REMARKS/ARGUMENTS

**Amendments to the Drawings:**

**Annotated Sheet Showing Changes**

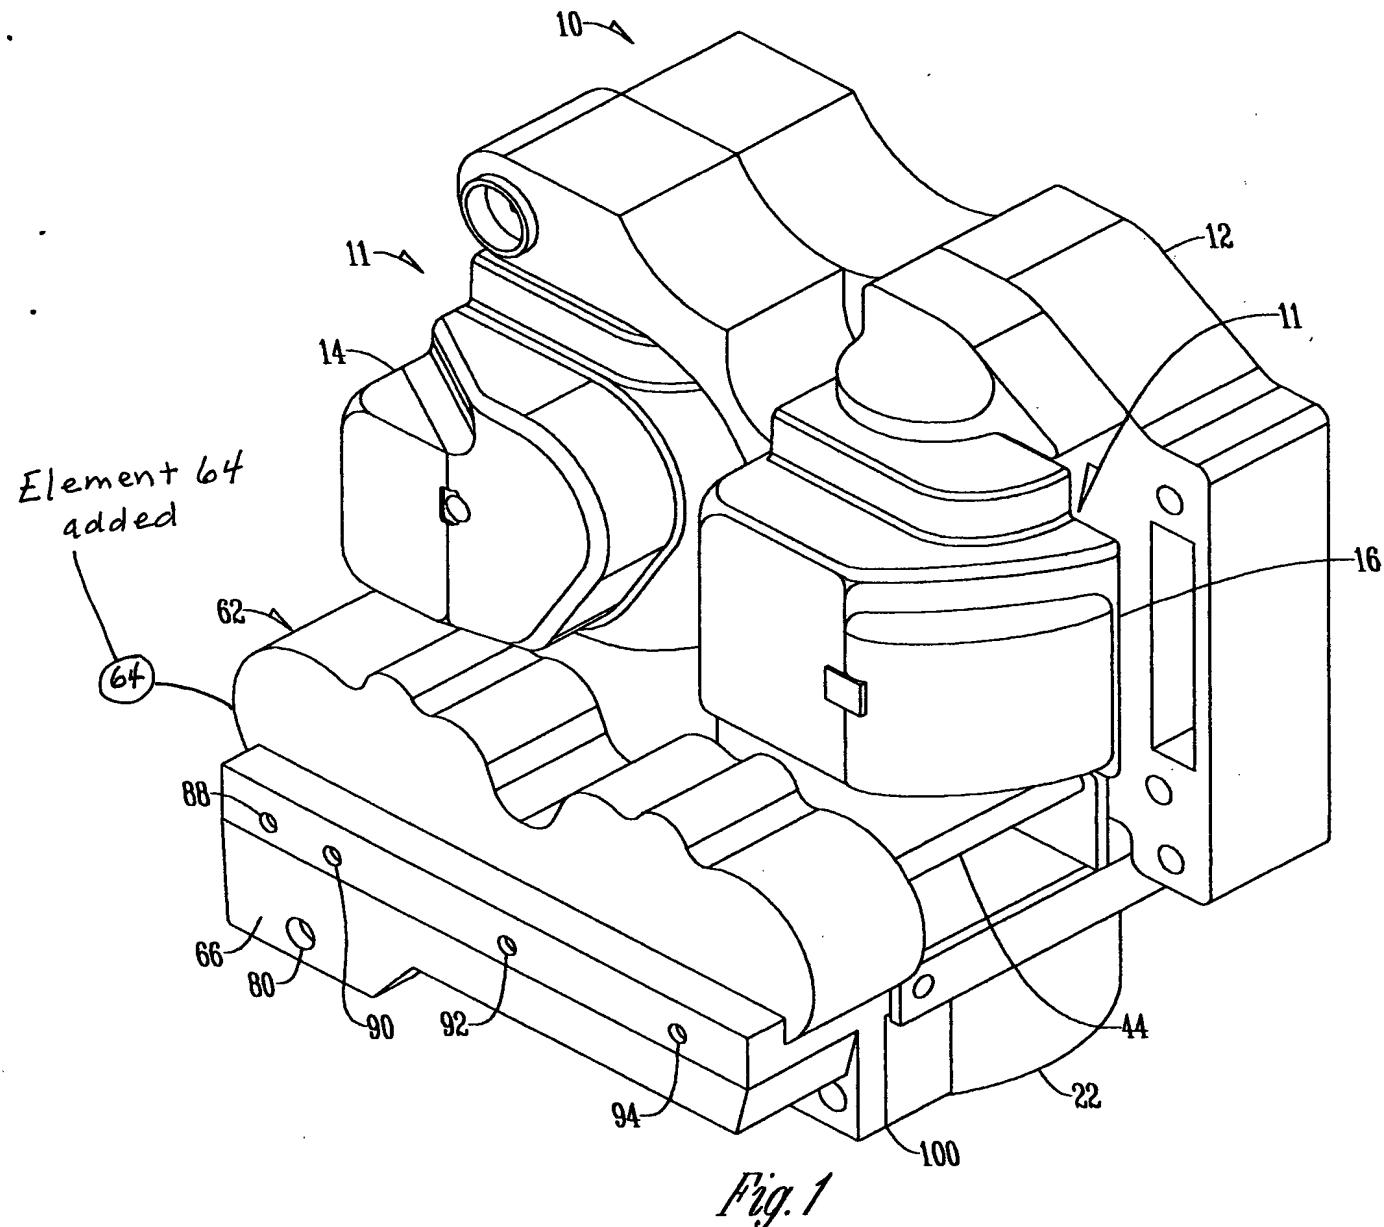
The attached sheets of drawings include changes to Figs. 1 and 3. These sheets, which include Figs. 1 and 3, replace the original sheets including Figs. 1 and 3. In Figs. 1 and 3, previously omitted element 64 has been added.
